## **Addendum #1**

### **T2 R9 Training Site Development Project Phase I**

#### **Project No. 23TC20-508 Bid Number # 20-041**

26 May 2020

**T2 R9 DEVELOPMENT 25 METER RANGE ACCESS ROAD**

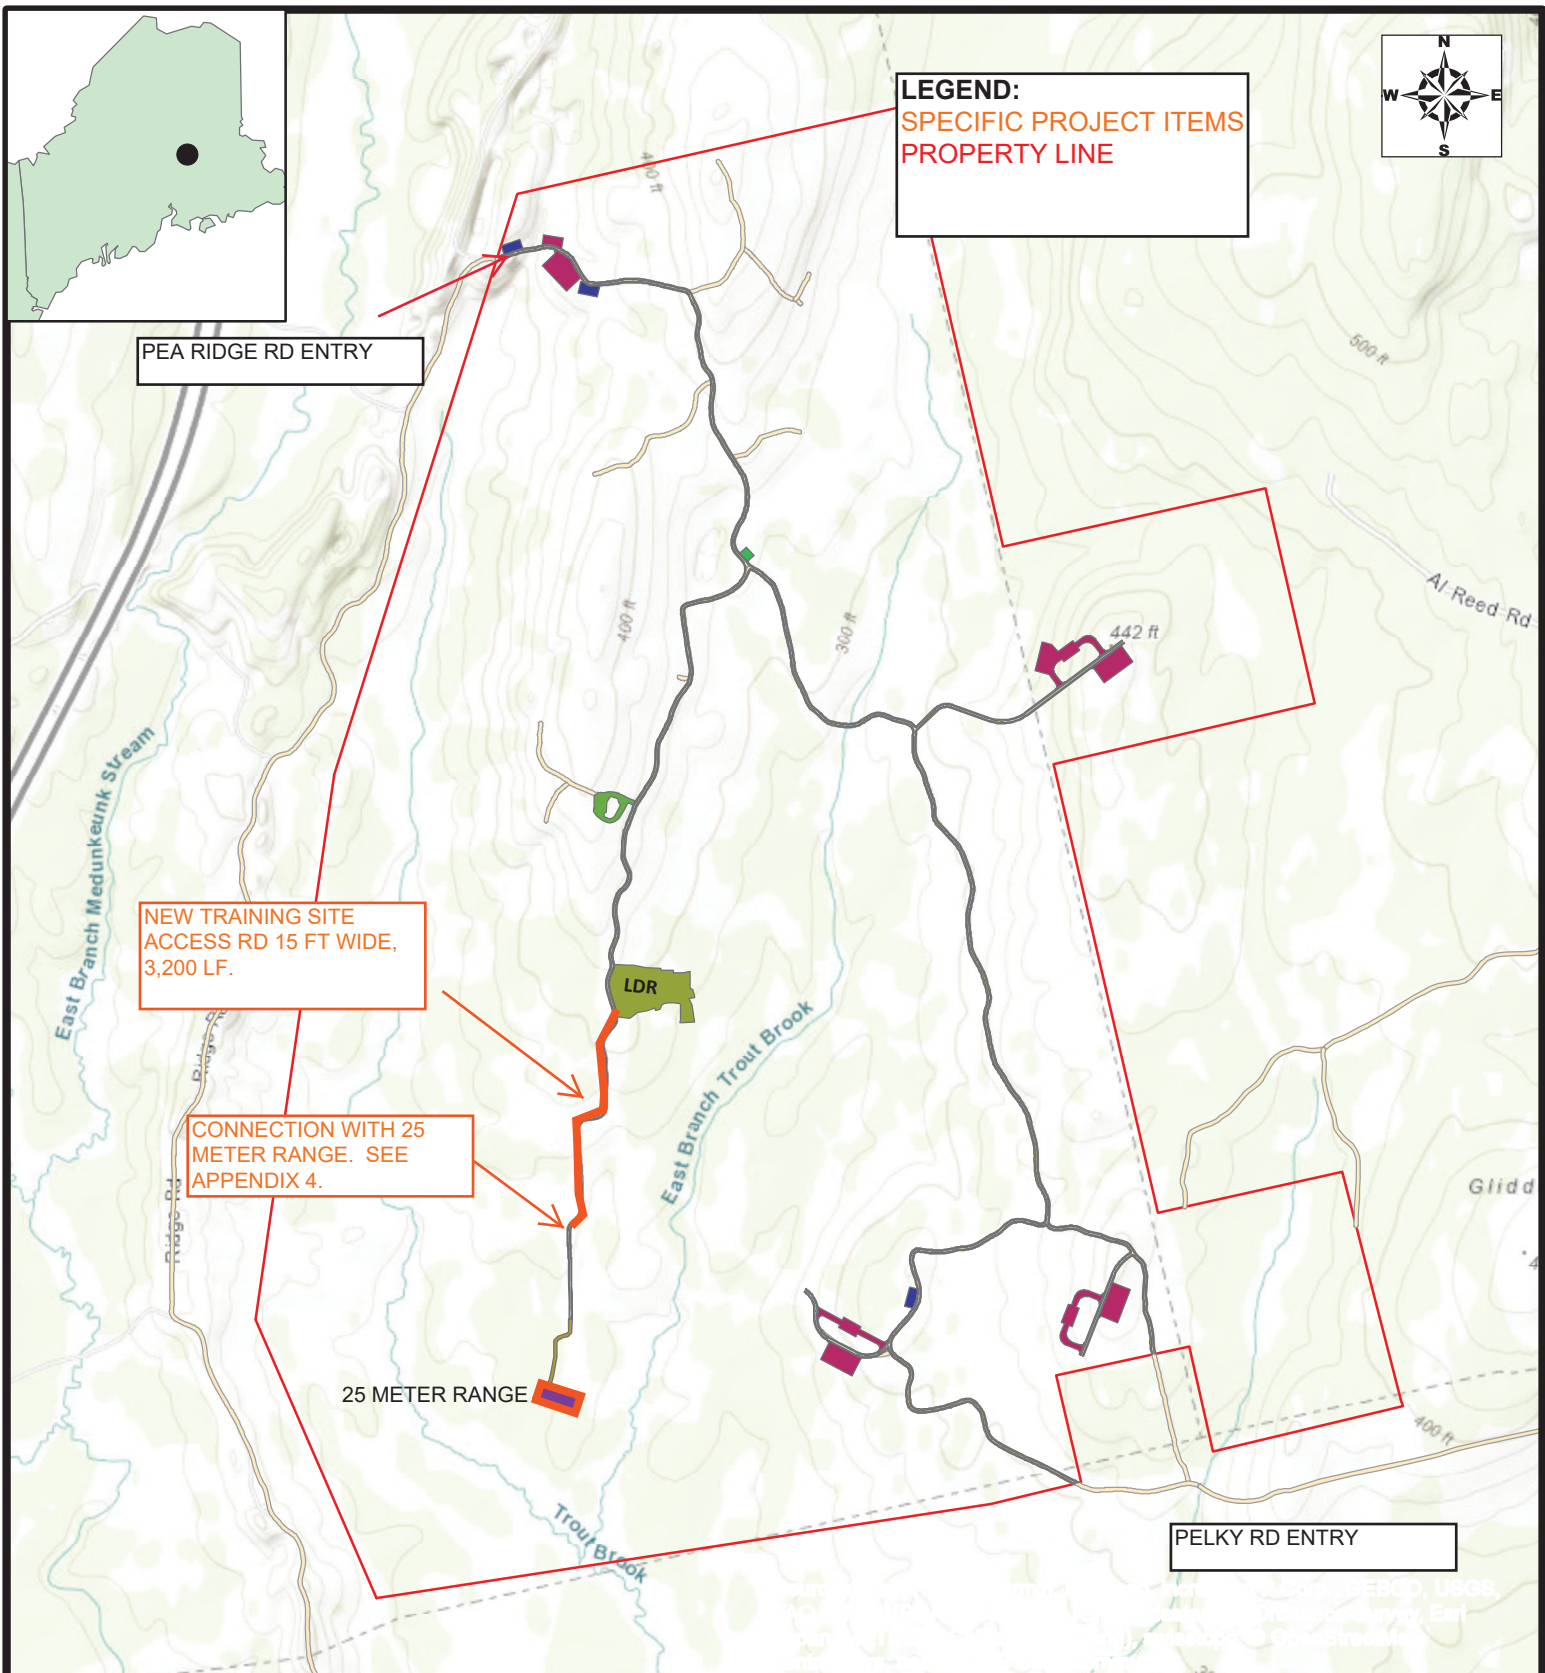
3. **Remove** cover Appendix 4, 25 Meter Range, and **insert** attached cover Appendix 4, 25 Meter Range. Corrected title.
4. **Remove** Map from Appendix 5, 25 Meter Access Road, and **insert** attached map. Corrects road width size from 24 ft. to 15 ft.

NEW TRAINING SITE  
 ACCESS RD 15 FT WIDE,  
 3,200 LF.

SHEET ID:  
 C-107  
 SHEET: 7 OF 15

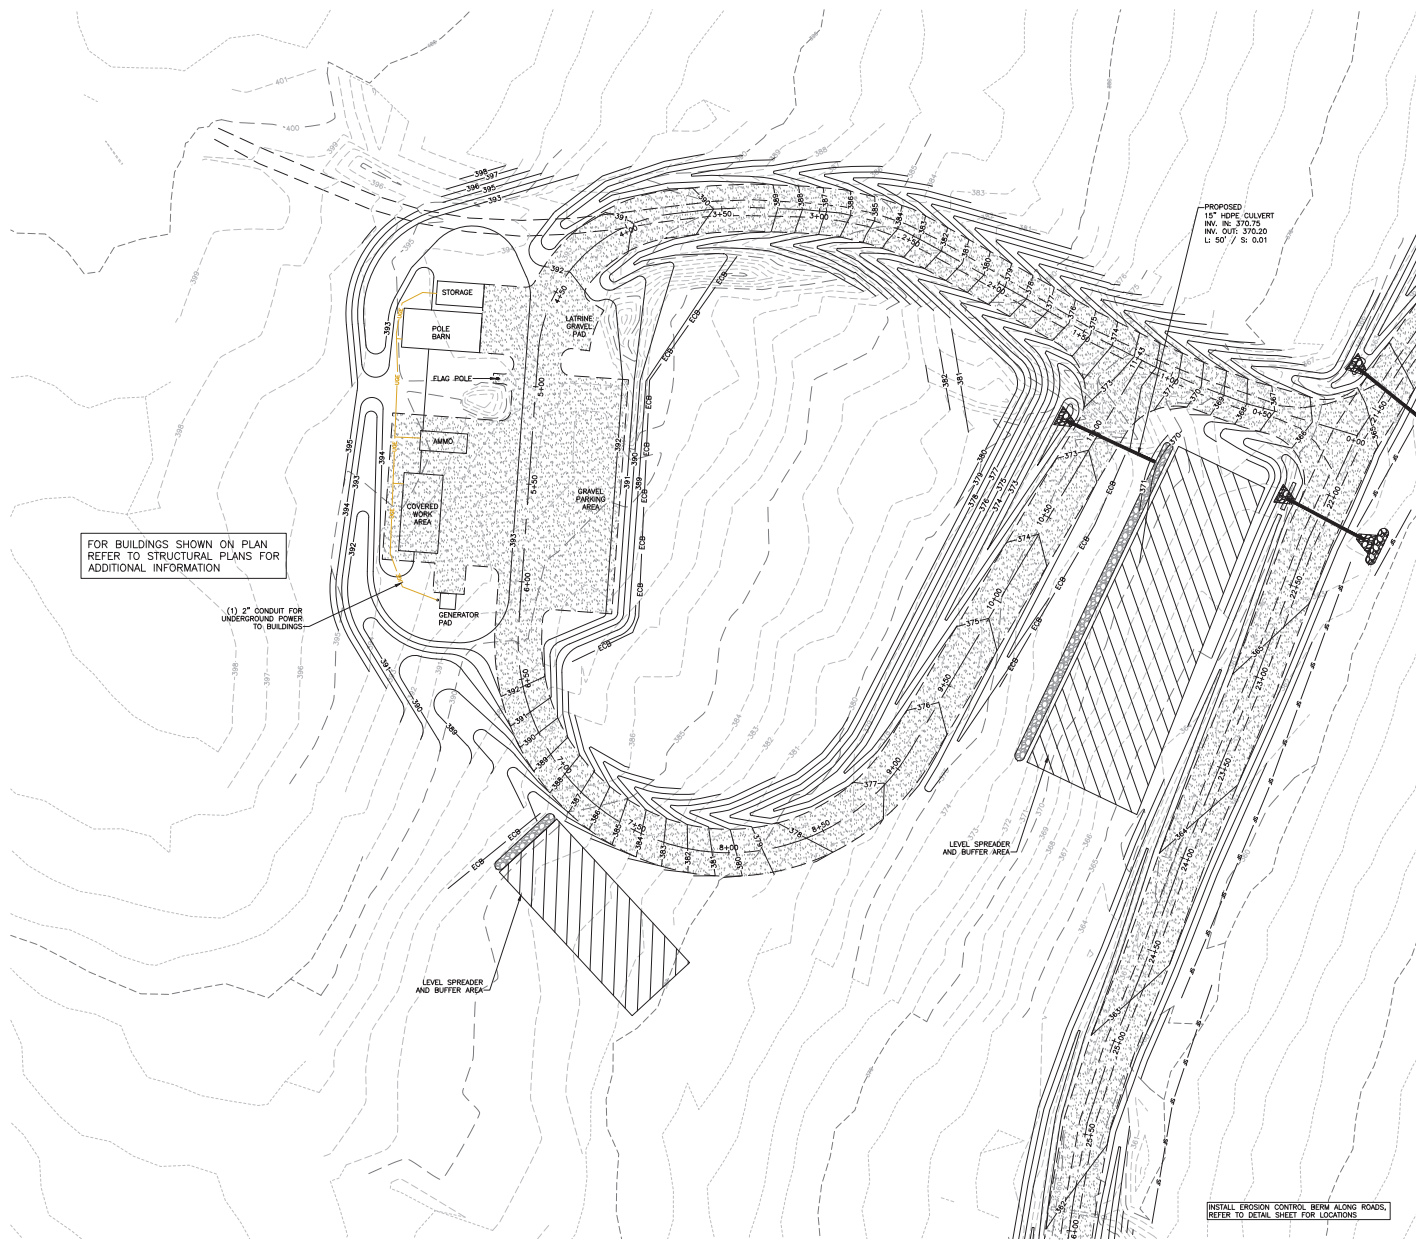
3. **Remove** Sheet C-107, T2 R9 Light Demolition Range Staging Area Site and **insert** attached Sheet C-107, T2 R9 Light Demolition Range Staging Area Site. This is for Appendix 10, T2 R9 Light Demolition Range Staging Area. Electrical Conduit Note.

(1) 2" CONDUIT FOR UNDERGROUND POWER TO BUILDINGS
